**Figure 2.10**  
**Infrastructure Design Review**  
**- Turbine 17**

**Bhlaraidh Wind Farm Extension**  
**S36C Varied Development**

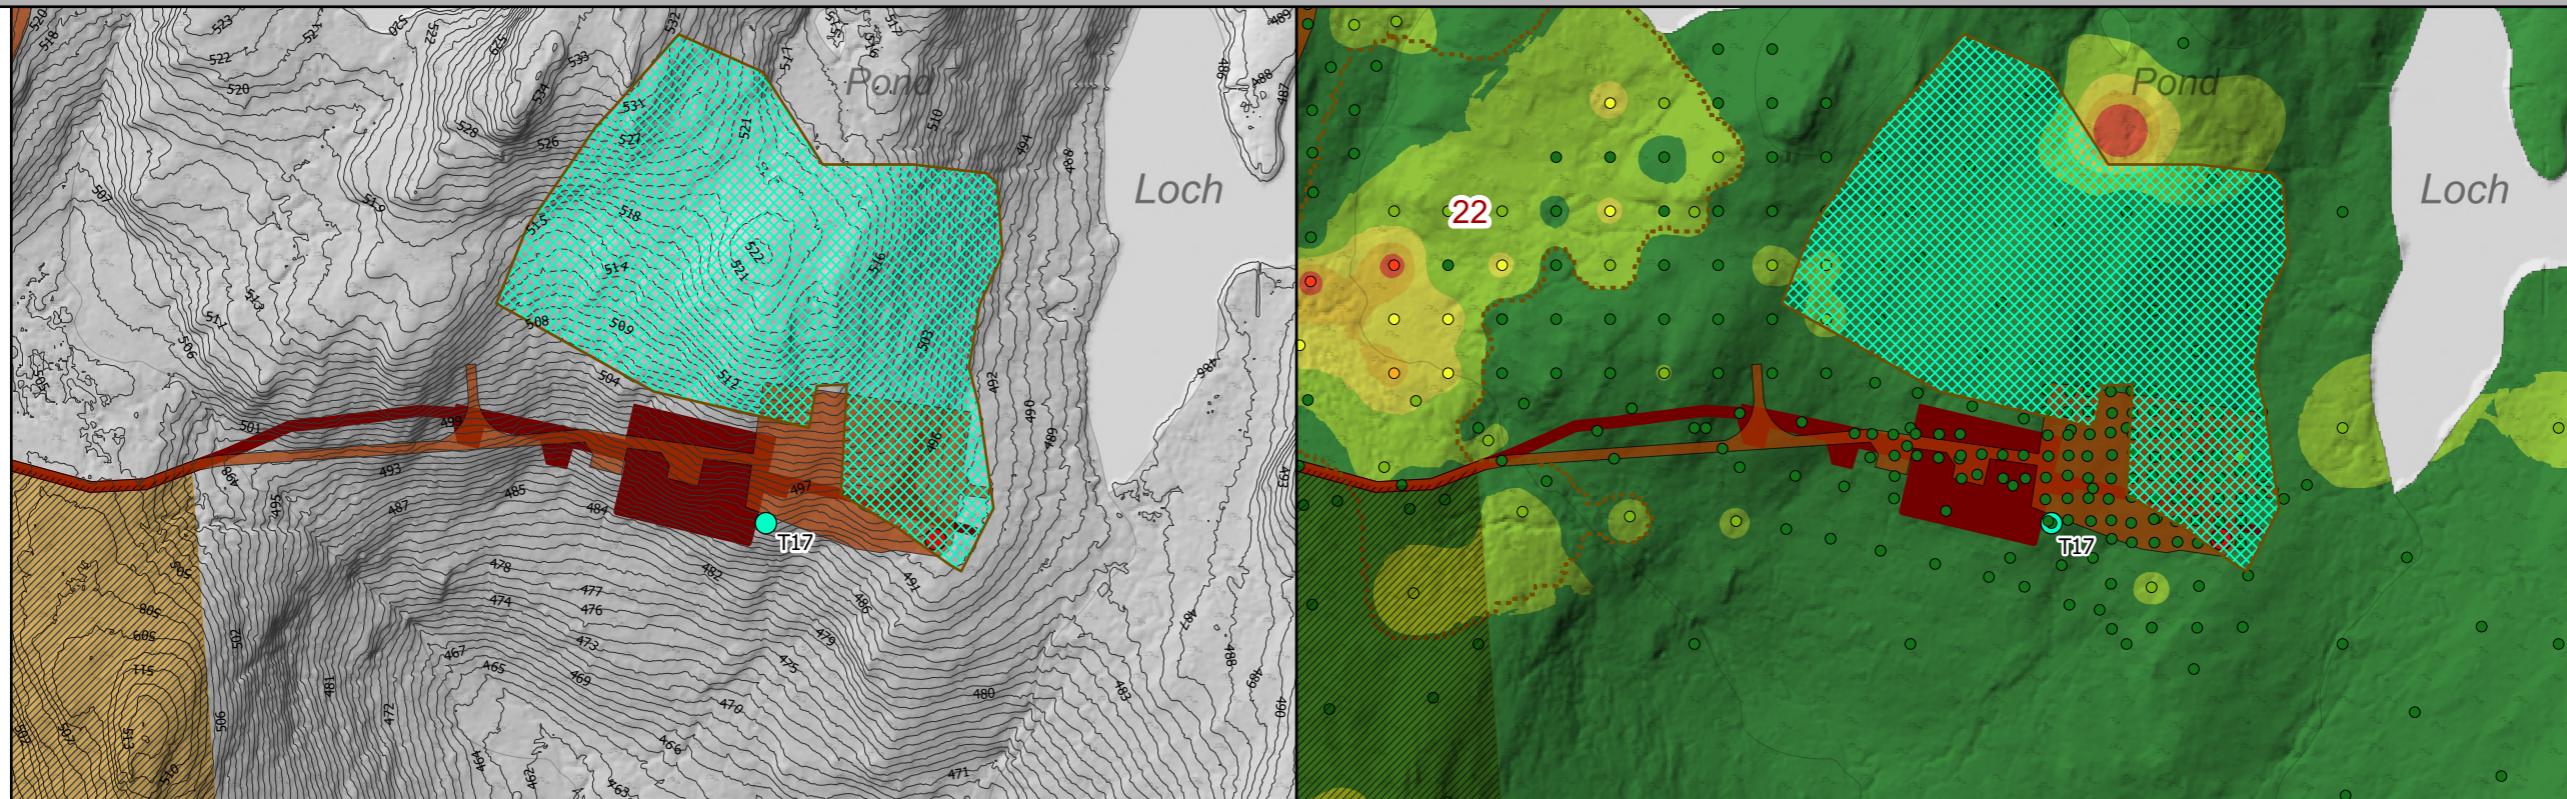
**T17: Reason for Moving:** Due to the relocation of turbines west of T17 and the need to maintain rotor spacing, this turbine has been sited further east.
